Subject: San Joaquin Solar 1 LLC and San Joaquin Solar 2 LLC  
Fresno County, California 08-AFC-12

# **San Joaquin Solar 1 & 2 Hybrid Project**

**Initial Response to CEC Data Request**

**Set #1, 08-AFC-12**

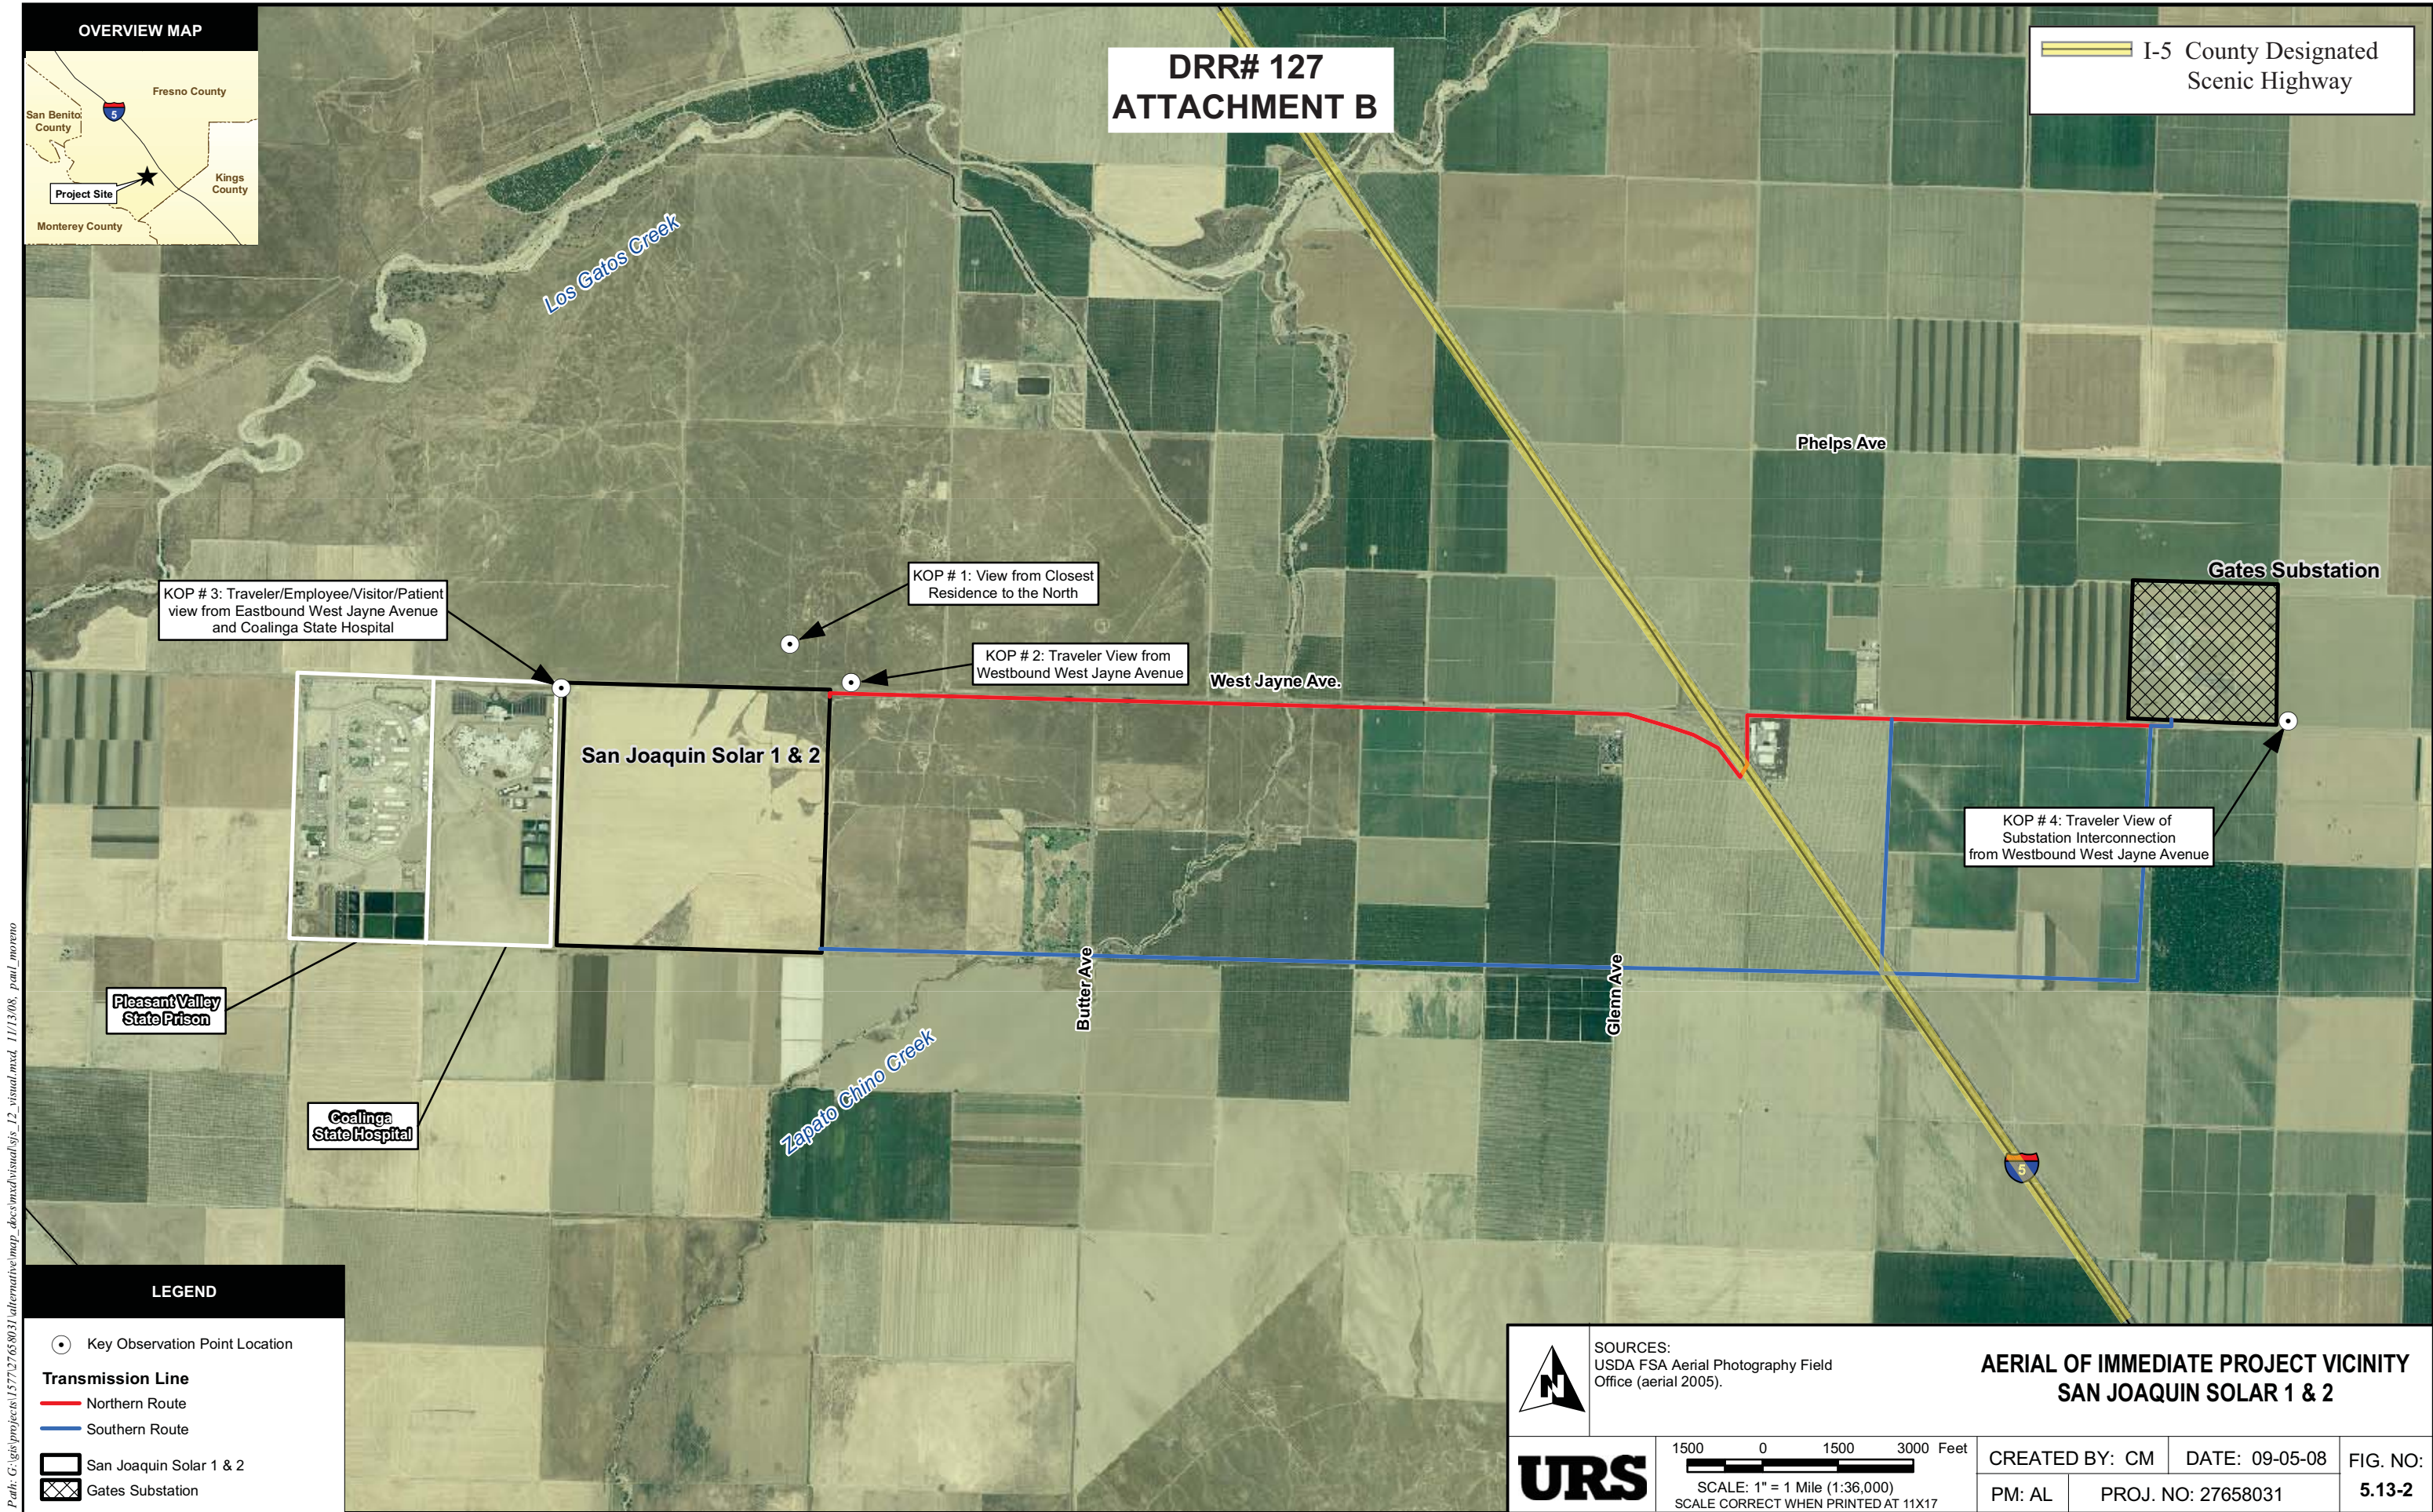
**Data Request 127:** Please describe the existing visual condition and analyze the visual effects associated with the new KOP consistent with the analysis of other KOPs in the AFC, including an evaluation of consistency with laws, ordinances, regulations and standards (LORS), and mitigation measures. Please provide a revised Figure 5.13-2 that shows the location of the new KOP and highlight the County scenic highway segment of I-5.

**Response:** Based on the responses to Data Request #126, no new KOPs have been prepared. According to the Conservation and Open Space Element of the County of Fresno General Plan (*October 2000, page 5-36*), the entire length of I-5 within Fresno County is a Fresno County Designated Scenic Highway. Figure 5.13-2 has been revised to highlight the length of I-5 shown in the figure. See Attachment B, next page.
